STATE OF NORTH CAROLINA  
DEPARTMENT OF TRANSPORTATION

SUBJECT: **Revision Request for Section 404 Regional General Permit No. 31 and Section 401 General Water Quality Certification No. 3886** for the proposed Interstate 85 (I-85) Widening and Interchange Improvements from north of NC 73 (Davidson Highway / Exit 55) to north of SR 2180 (Lane Street/Exit 63), Cabarrus & Rowan Counties, Divisions 9 and 10. Federal Aid Project No. FANHIMF-085-2(61)55, TIP Project No. I-3802A.

Revisions have been made at Sites 7, 7A, 14, and 22. Below are descriptions of the revisions at each of these sites. In addition to this cover letter, please find enclosed revised Wetland and Stream Permit Drawing Sheet Nos. 15 – 20, 41 – 44, 71 – 74, and 126 – 128 of 128; and the revised Mitigation Acceptance Letter from the N.C. Division of Mitigation Services (DMS).

**MODIFICATION**  
 9/26/2017  
**PERMIT DRAWING SHEET 43 OF 128**

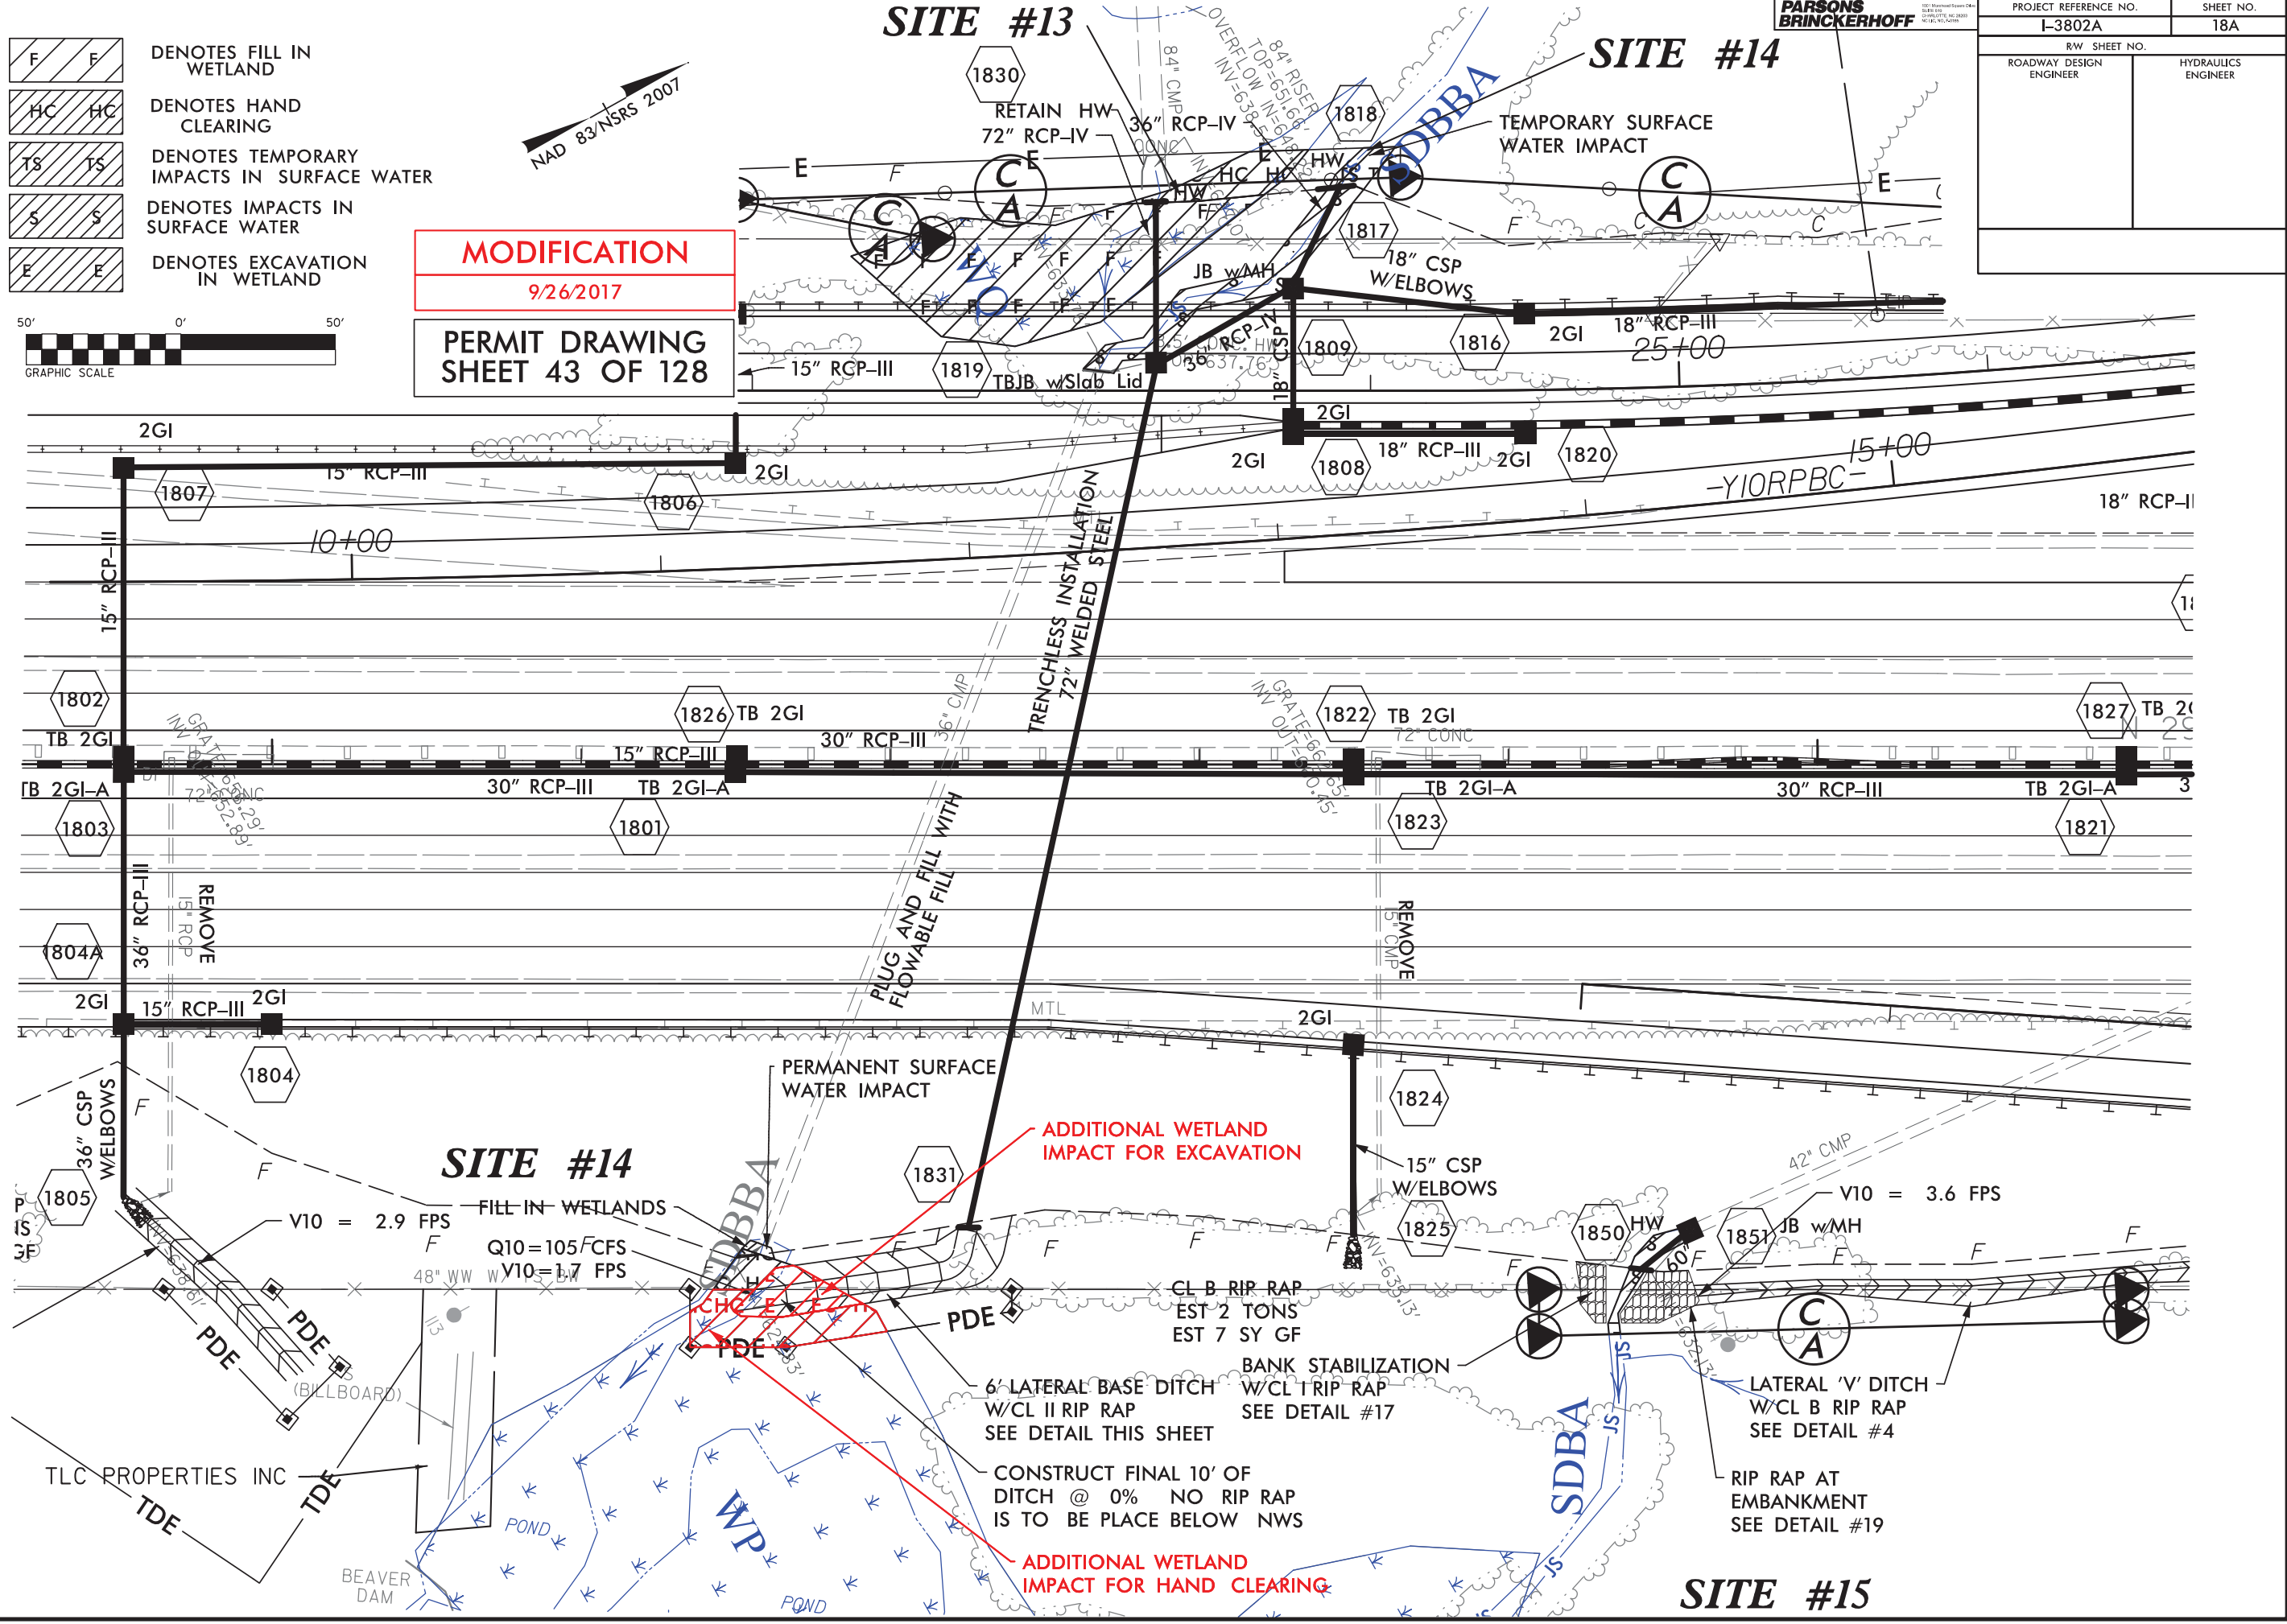
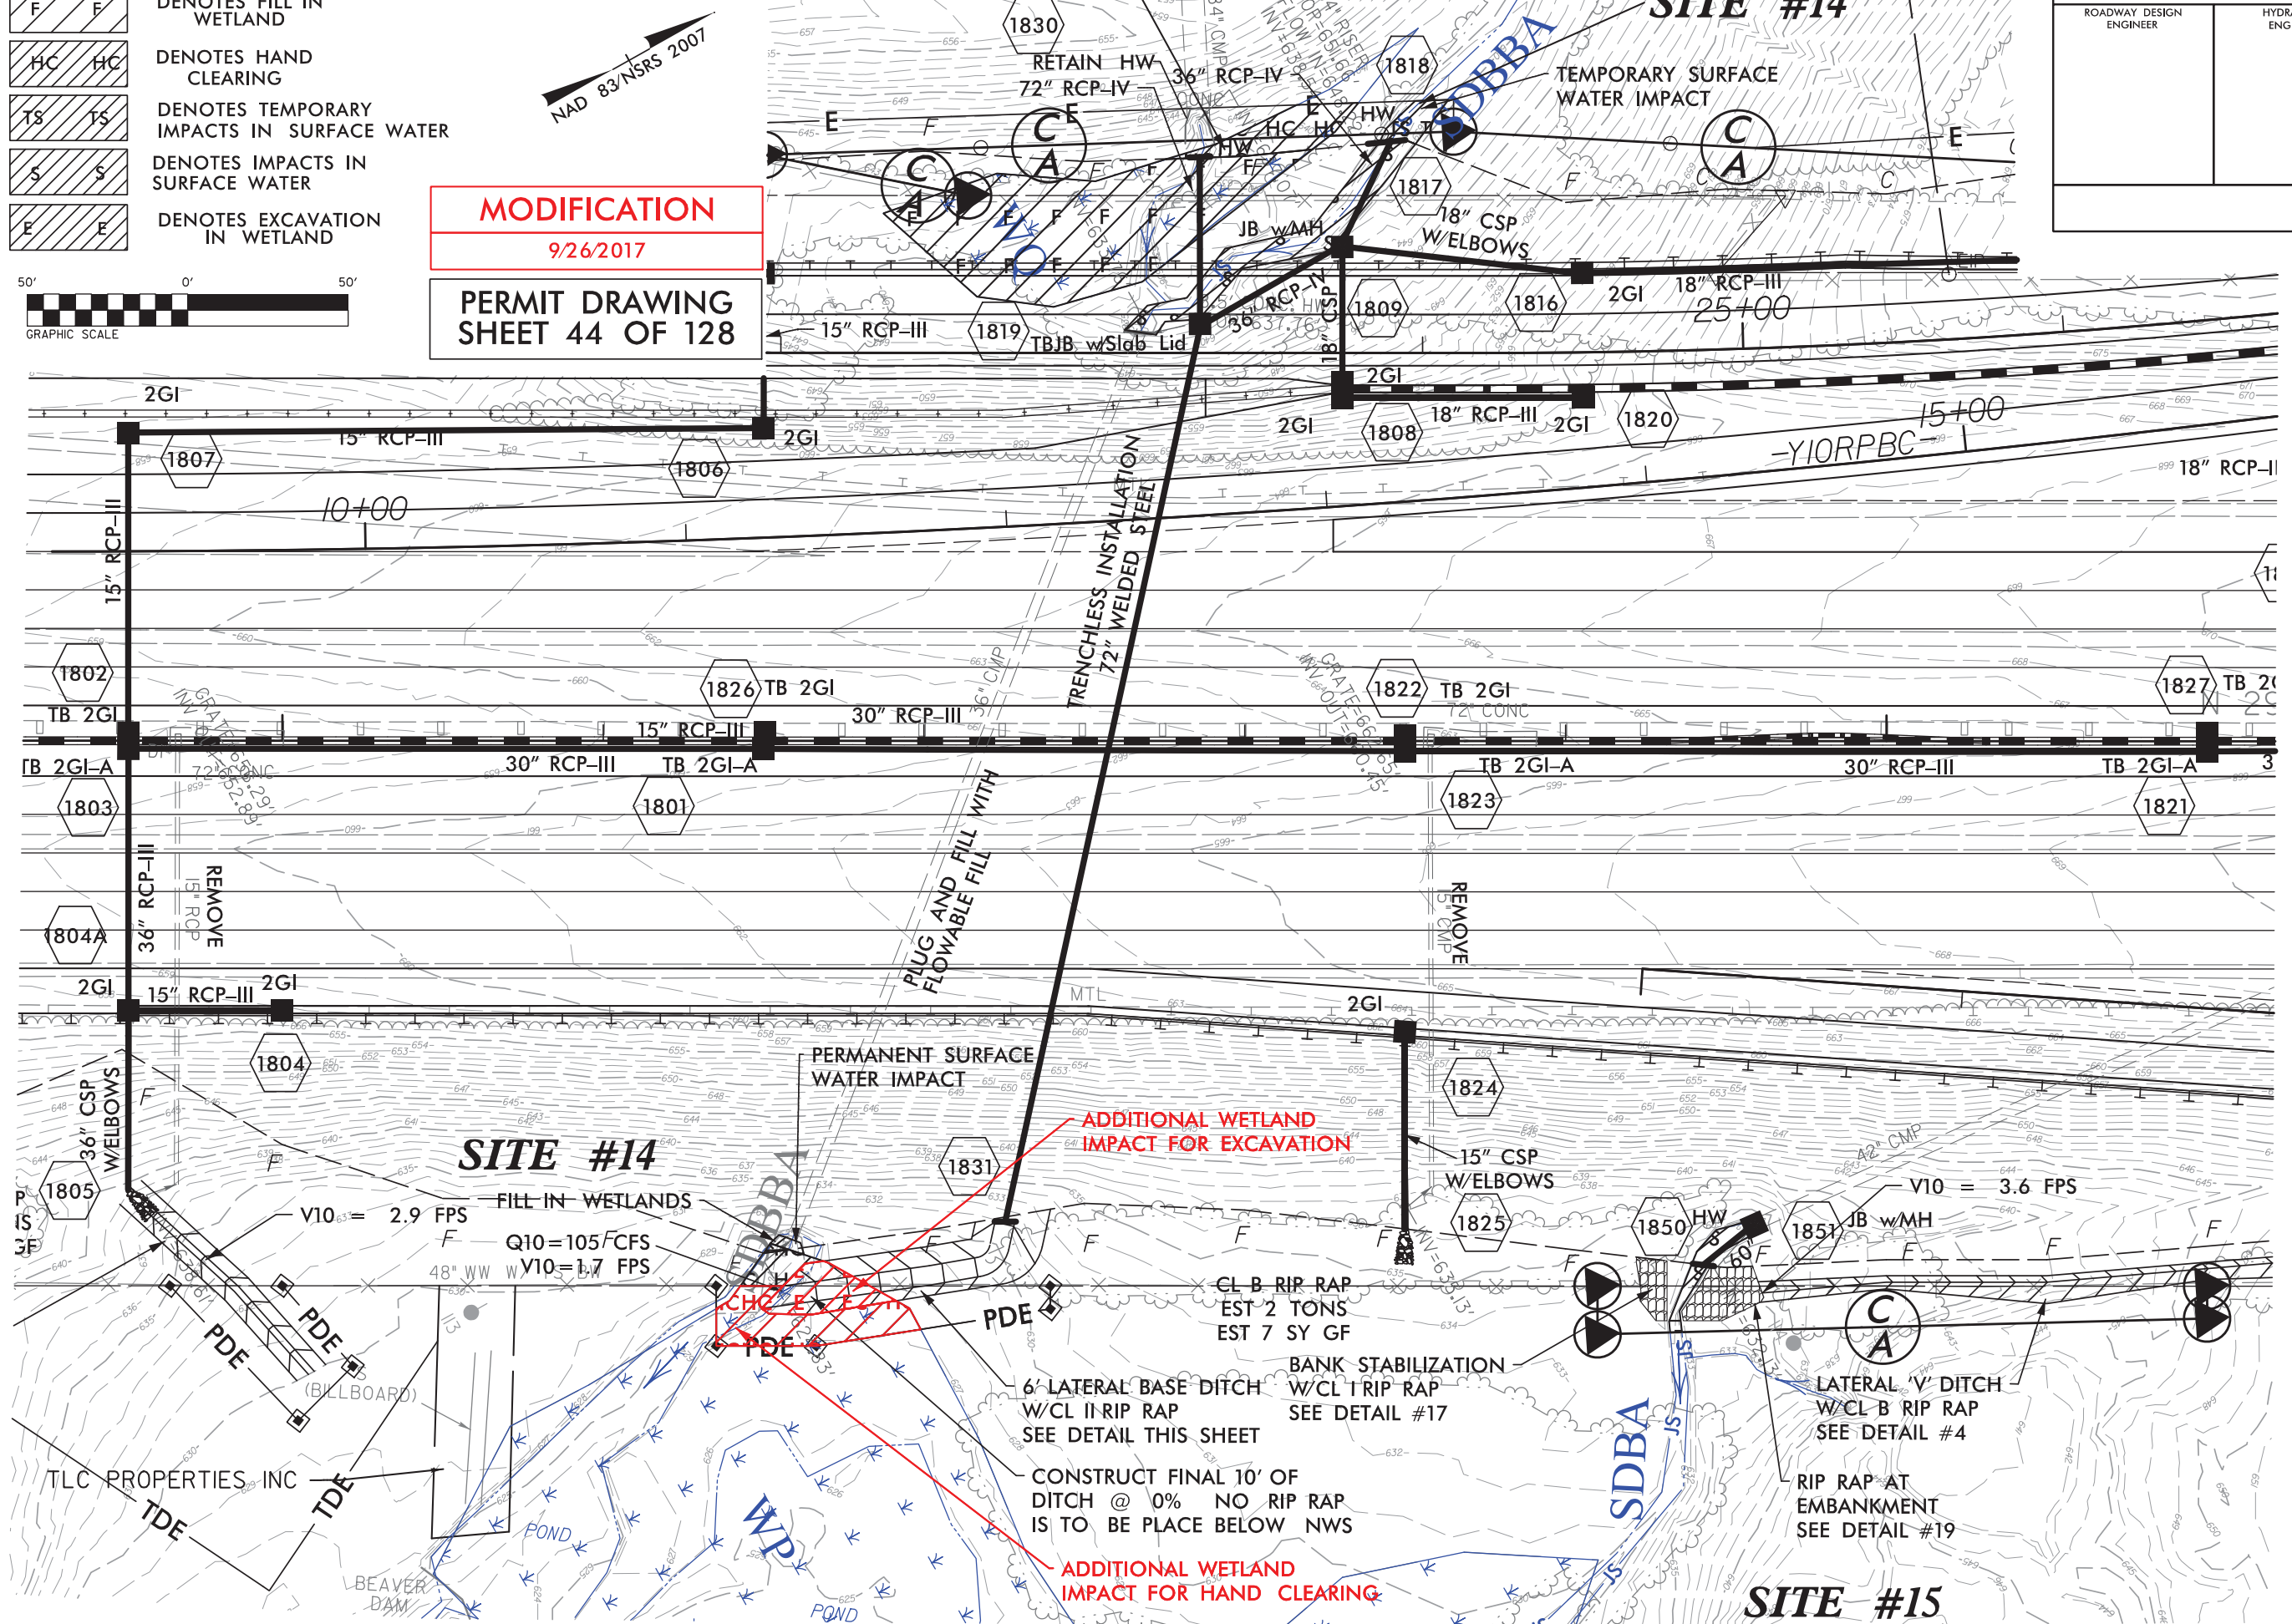
### *Wetland and Stream Permit Site 14 (Wetland WP)*

The original design on Plan Sheet No. 18 called for the extension of a 36-inch corrugated metal pipe (CMP) underneath the roadway and associated stormwater system improvements on the upstream end of the pipe. It has since been decided to plug and fill the existing 36-inch CMP and install a 72-inch welded steel pipe via trenchless installation adjacent to the existing pipe. The stormwater system has been modified to connect to this new pipe configuration. This design change resulted in the addition of 0.02 acres of excavation (this is a new impact) and 0.02 acres of hand clearing at this site (previously, there was only <0.01 acres).

ADDITIONAL WETLAND IMPACT FOR EXCAVATION

ADDITIONAL WETLAND IMPACT FOR HAND CLEARING
